INTERIM RECORD OF DECISION
FOR THE OPERABLE UNIT 1 SOURCE AREA GROUNDWATER

NATIONAL AERONAUTICS AND SPACE ADMINISTRATION
JET PROPULSION LABORATORY
PASADENA, CALIFORNIA

December 2006

Figure 9-1. Layout of the Existing Demonstration System and the Expansion Area

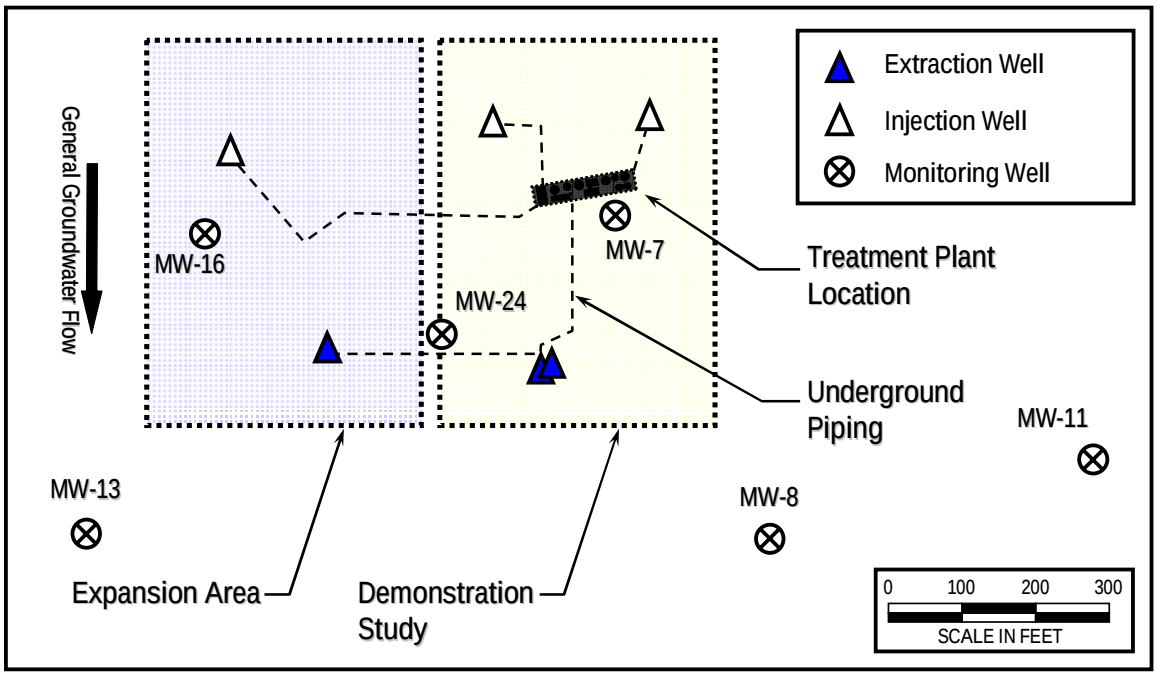
6b. Specific Comment, Page 2:
The Proposed Plan states, "Figure 2 shows the layout of the existing demonstration study system and the proposed expansion. One or two new extraction wells and one or more injection wells will be installed as part of the proposed expansion. The actual number and location of wells will be determined as part of the design phase."

It is unclear if the design refinements will resolve the apparent discrepancy between the proposed expansion, as described in Figure 2 of the Proposed Plan, and Phase II, as described in Figure 1-2 of the ETS Work Plan.

NASA Response:
The design refinements will be documented in an OU-1 Treatment System Expansion Work Plan and will resolve the difference between what was proposed in the Expanded Treatability Study Work Plan (Figure 1-2) and the Proposed Plan (Figure 2).
